Re: Addendum to Report of Subsurface Exploration for SR 823 Bridge over Slocum Avenue (TR-248), SCI-823-0229 L & R, SCI-823-0.00 Portsmouth Bypass (PID #77366), dated September 6, 2007

**SUBJECT: Structure Type Study Resubmission # 3
SR 823 over Slocum Avenue
SCI-823-0.00 Portsmouth Bypass
PID#19415**

**REPORT
OF
SUBSURFACE INVESTIGATION
FOR
EMBANKMENTS (STATION 416+00 to 509+50)**

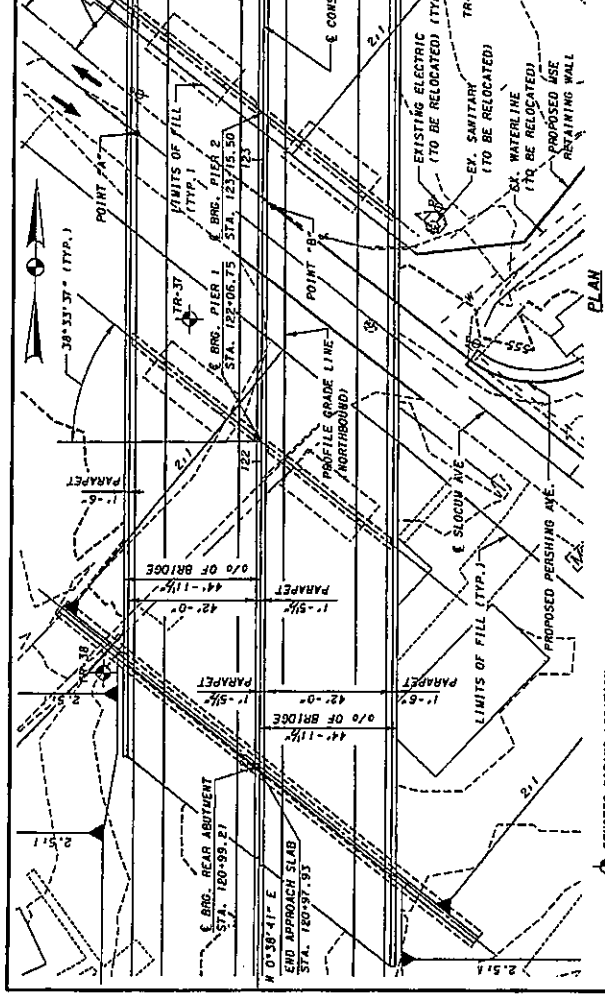
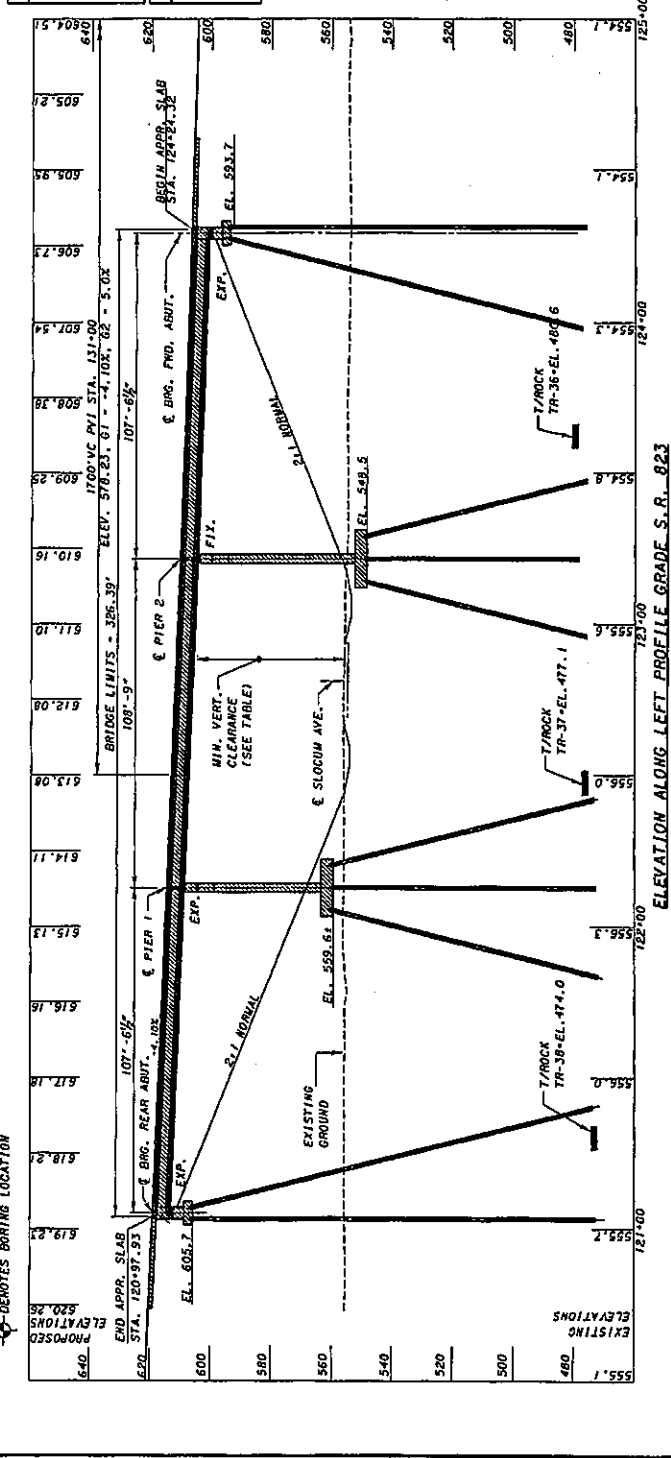
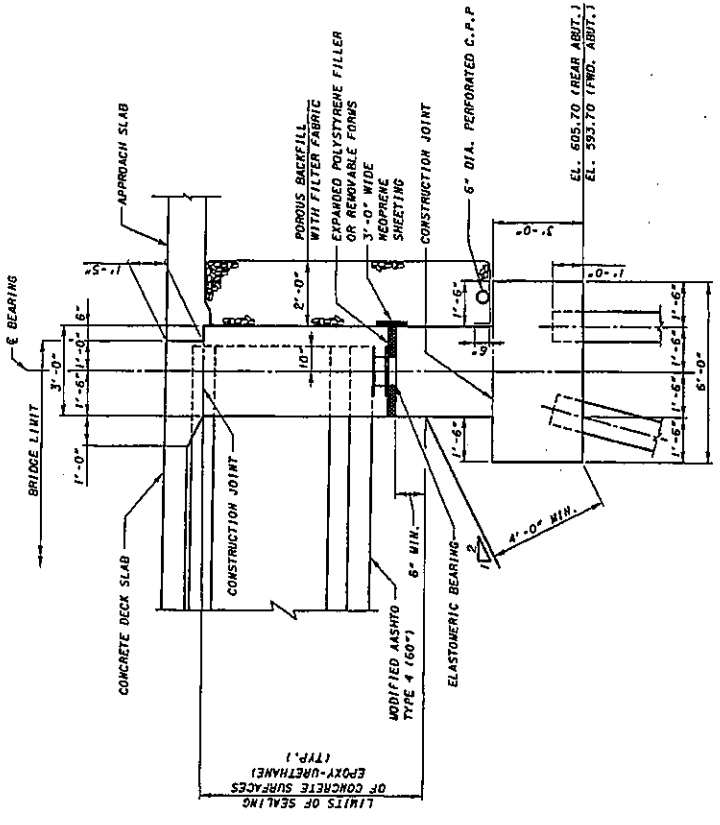
- 1. We agree that the proposed superstructure can consist of three spans of prestressed concrete I-girders made composite with the deck. We agree that the substructures should consist of reinforced concrete T-type piers supported on piling and semi-integral abutments supported on piling.*

- 2. We agree that MSE walls should not be utilized at this location due to the wall height (60 feet) and the subsurface conditions [low strength and large settlements (21")]. The unit cost of the MSE walls given in the cost analysis [high wall, >50', \$85/ft² (2005)] appears to be appropriate. The estimated cost for a average wall height [25'-35' is approximately \$50/ft² (2005)].*

- 3. Relatively long structures (>200') on somewhat steep grades (>3%) have experienced high forces caused by movement toward the low end of the structure. Investigate utilizing fixed elastomeric bearings at the forward abutment (with semi-integral abutment details) along with the proposed fixed bearings at the forward pier. The flexibility of the pier and abutment should be enough to accommodate the expansion of the forward span (<1").*

4. *Consider utilizing 3 equal spans due to the fact that the same beam design and strand arrangement will be utilized for all beams and this should result in a more economical design. The 0.7 to 0.8 span ratio, of end span to intermediate span, is a general statement that is intended for steel beams and girders. It appears that there is adequate lateral clearance from Slocum Avenue to accomplish this.*

5. *Verify the bridge length (322.52'). Verify the beam length center to center of bearing. Does the bridge length take into account the distance between the centerlines of bearing at the piers? The span lengths shown in the Profile view on the Site Plan are shown as the centerline of bearing at the abutment to the centerline of the pier cap not the centerline of bearing for the beams.*

6. *Can the overall bridge length be shortened by increasing the height of the breastwall (if a 5 foot high breastwall is utilized at each abutment the bridge length can be shortened by 20 feet)? At what point does the breastwall/abutment cost outweigh the savings in bridge length?*

7. *The result of comment numbers 5 and 6 may make it possible to decrease the size of the beam that is required.*

8. *When the alignment is finalized include the stationing portion of the bridge number in the Title Block.*

9. *After the Bridge Number is determined the Structure File Number can be obtained by calling our office (Kathy Keller 752-9973).*

10. *Include a detail (including the reinforcing) of the barriers in the center of the bridge in the Detail plans.*

11. *Include the location (longitude and latitude) of the Structure in the Proposed Structure data block.*

12. *We agree that the abutments and piers should be supported on H-piles (HP14x95) with a maximum capacity of 95 tones per pile. The estimated pile length should be 140 feet and 130 feet for the rear abutment and forward abutment respectively. The estimated pile length should be 95 feet and 80 feet for the rear pier and forward pier respectively.*

Comment noted.

Comment noted.

Comment to be given consideration by the final design consultant however, our response follows. It is recommended that the final design first investigate resolving this force into the fixed pier and, if required, investigate adding resistance at the abutment. Resolving the horizontal force through the abutment requires consideration of the pile foundation stiffness. Discussions with OSE staff indicated that it is also important to check the superstructure to substructure connection and that it may be a weak point. We have investigated the horizontal force due to the self weight of the structure and found that it will add considerably to the longitudinal design forces at the fixed pier. The analysis used supports with stiffness in the longitudinal direction equivalent to preliminary bearing/substructure stiffness. It is recommended that the final design calculate and account for the force in a similar manner.

The attached site plan presents three equal spans. Fabricators indicated that detailing the same strand pattern for all of the beams allows them more flexibility within the casting beds. Consideration should be given to specifying the pour sequence in standard drawing PSID-1-99 to minimize cracking that could occur at the pier.

The attached Site Plan more accurately indicates the spans are measured to the centerlines of the substructures.

We have investigated shortening the superstructure by increasing the breastwall height on SR 823 over Morris Lane-Blue Run Road (July 21, 2006). The construction cost analysis found that reducing the superstructure length 20' increased the construction and total ownership costs. The additional cost of the abutments and long piles, common at both structures, quickly offset the cost savings in the superstructure. This comment was discussed with OSE staff and it was generally agreed that it was not to be given additional consideration. The substructure/superstructure balance may be different with lighter steel superstructures and the higher painting cost.

Using equal spans allowed for the use of a 60" Modified AASHTO Type 4 beam. The preliminary analysis used 6ksi and 8ksi concrete strengths; similar to the 9/6/06 Type Study.

The attached Site Plans include the bridge number.

The SFN will be included in the TS&L submittal.

Comment to be given consideration by the final design consultant.

The attached Site Plans include the location of the structure.

Comment to be given additional consideration upon completion of the final borings.

MSE WALL STABILITY ANALYSES

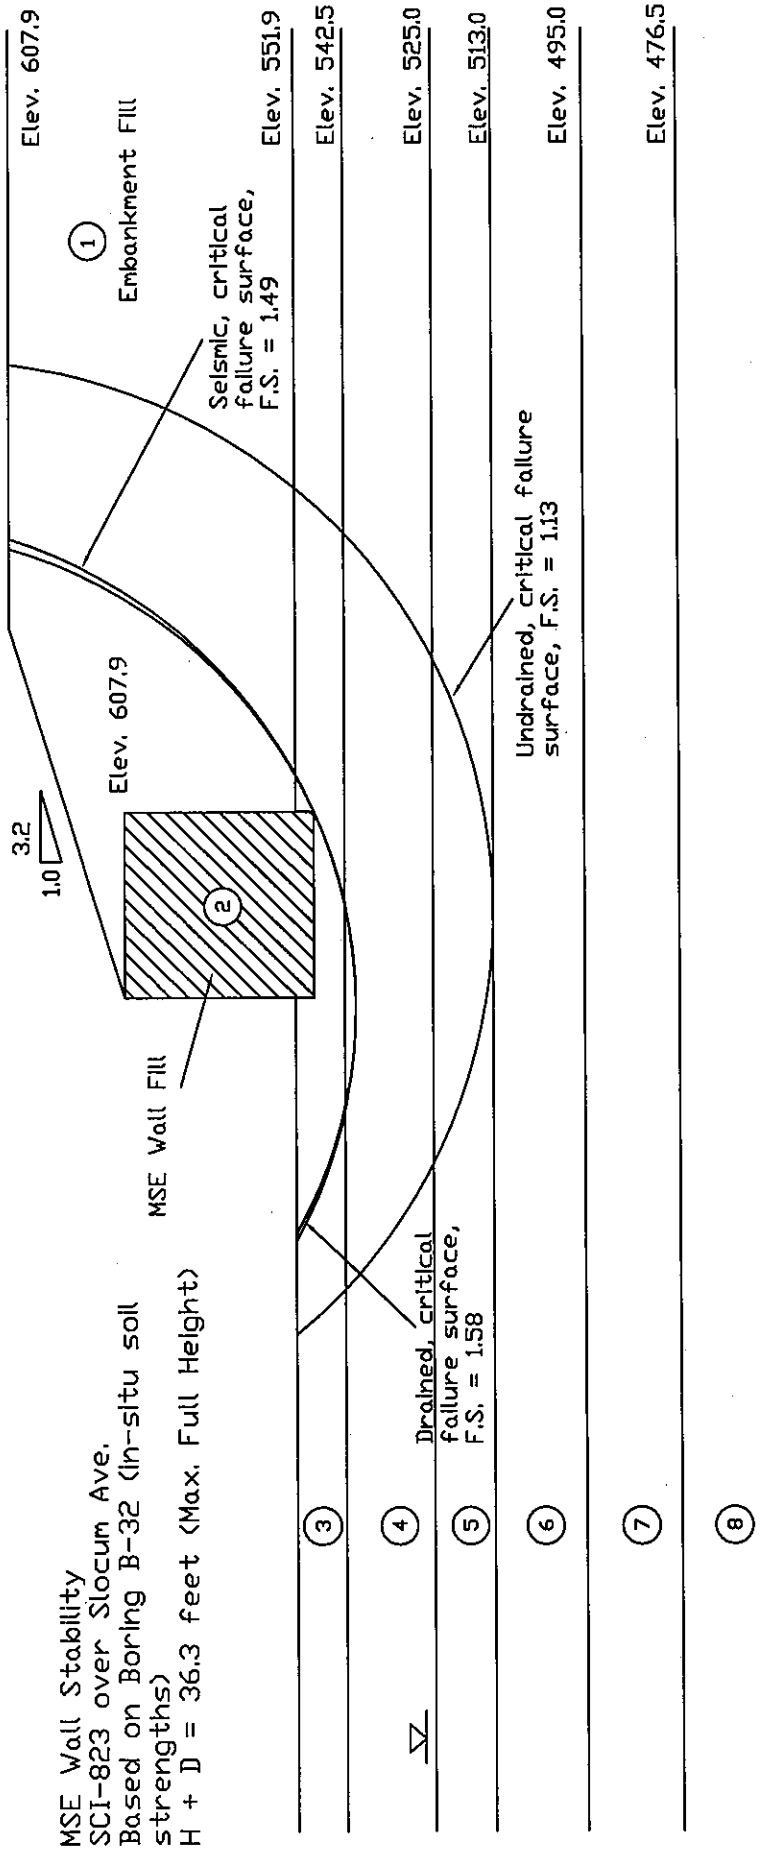
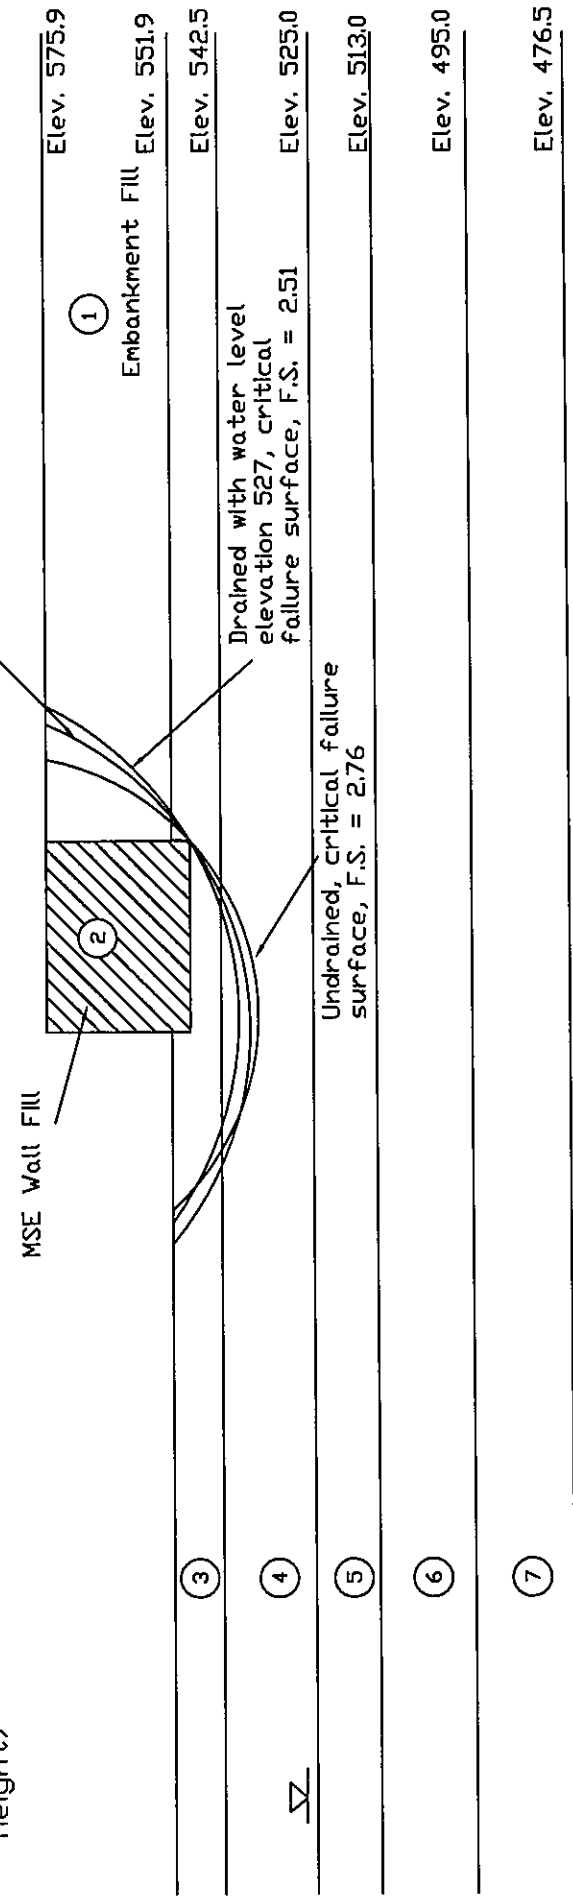
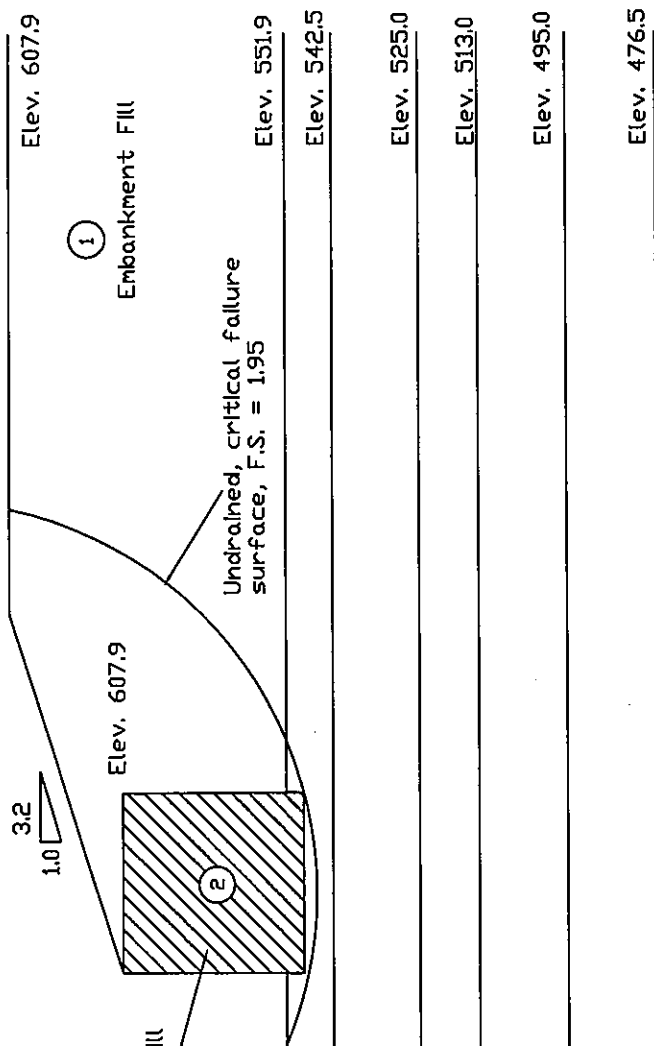
4. *A traffic load of 240 pounds per square foot was used in the MSE wall analyses. However, since the MSE wall would be located from the proposed bridge at a distance more than one-half the maximum wall height, traffic loads should not be considered.*

5. *A 3.2:1 (H:V) backfill slope perpendicular to the highest wall section was used in the analysis. However, according to the preliminary wall design plans, the backfill slope perpendicular to the highest wall section would be level and the 3.2:1 (H:V) backfill slope would be at a wall section approximately 25 feet northeast of the highest wall section. Please clarify your assumptions made in the selection of wall section.*

The stability analyses for the MSE wall were performed without a traffic load. The analyses indicate a slight increase in the factors of safety for overturning,

sliding and bearing capacity. However, these increases do not change any of our original recommendations concerning the MSE wall. A copy of the stability analyses without a traffic load is attached.

It is understood that the backfill slope perpendicular to the highest wall section will be level. However, since the backfill slope will vary along the wall alignment, any backfill slopes that are out of square with the highest wall section would be non-zero slopes. As a result, the highest wall section with a level backfill slope was not used for the analysis. Since the sloping backfill will create different loading conditions than the level backfill, the wall was analyzed using a critical wall section, which consisted of the highest wall height and a 3.2:1 (H:V) backfill slope.
